Subject: Transmittal of Work Plan
Winner Ford, 1650 Park Street, Alameda, California.

WORK PLAN FOR A SUBSURFACE INVESTIGATION

Winner Ford
1650 Park Street
Alameda, California

Work Plan No. 3002.11

HORIZON ENVIRONMENTAL INC.		SITE PLAN WINNER FORD 1650 PARK STREET ALAMEDA, CALIFORNIA	FIGURE 2
Project Number: 3002.11 Prepared By: G. Barker Reviewed By:	Drawn By: D. Alston Date: 2/96 Revised Date:

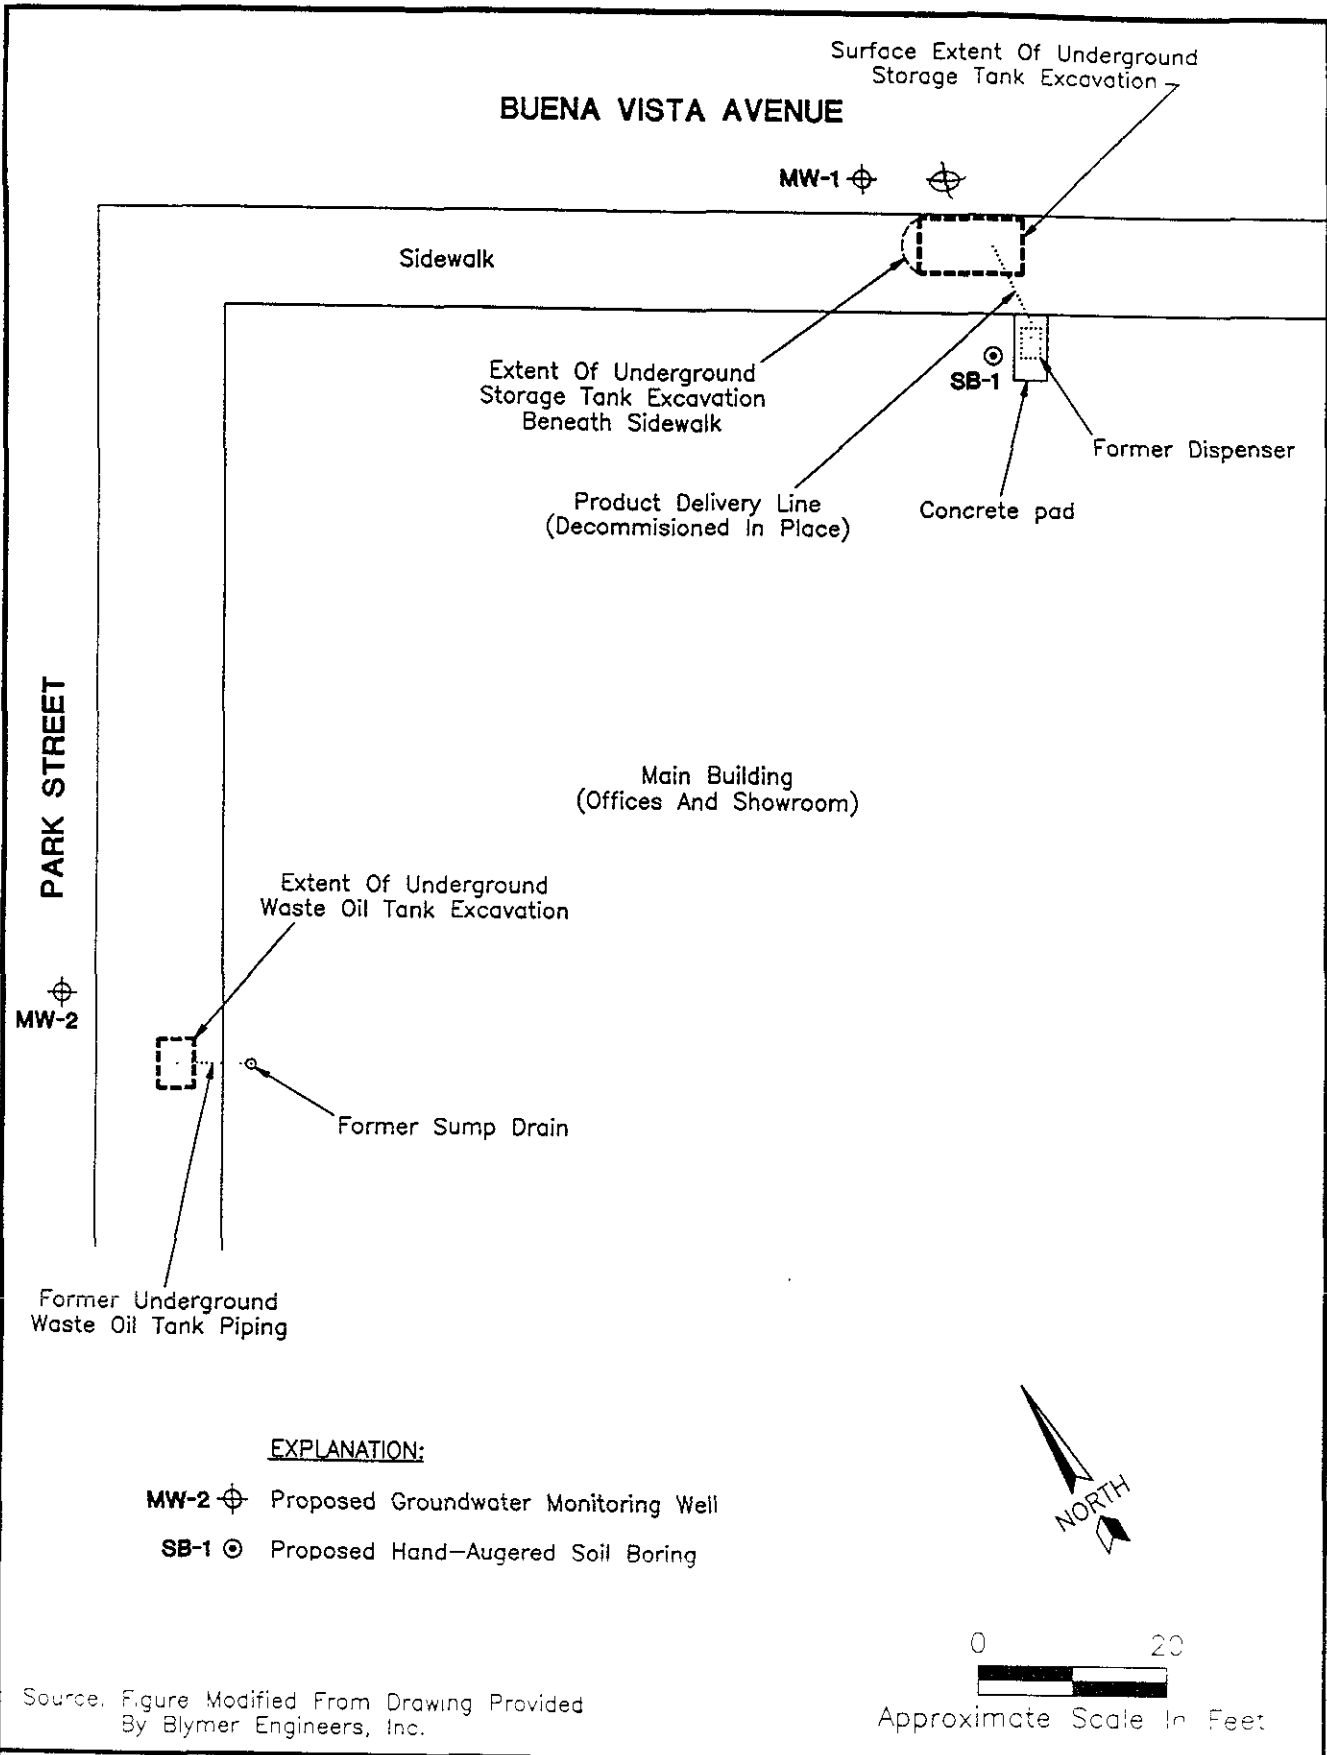
then MWS proposed should be more N-NE of former tank pit!

Site plan shows hand auger is next to dispenser island. It should be through former island to delineate vertical extent of soil contam.
